## Technical information

# OYSTER TUBES AND CROWNS

## NEW ASSORTMENT

#### INTERCHANGEABILITY

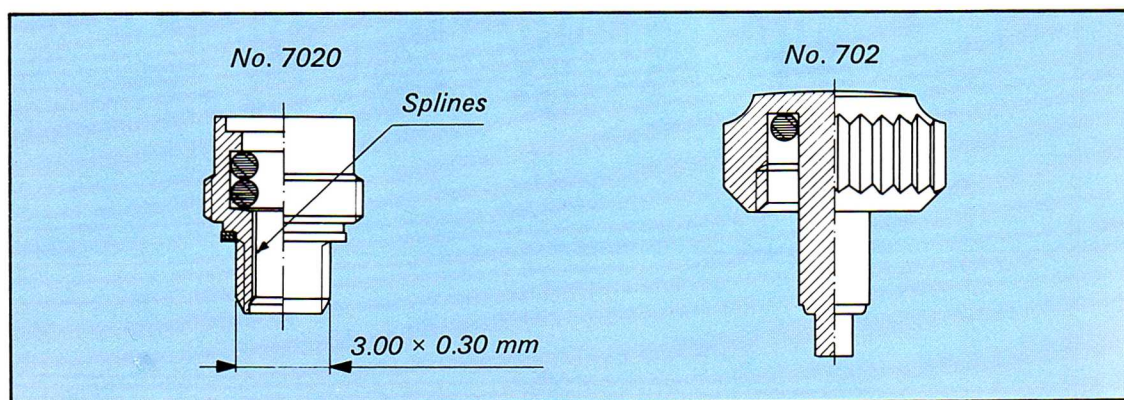
The tubes with old type splines Nos. 5300 and 5310 can be replaced by the tube No. 5330, the tube No. 6000 by the tube No. 6010 and the tubes No. 7000, respectively No. 7020, by the tube No. 7030, for as much as the crown No. 700, respectively No. 702, be also replaced by the crown No. 703.
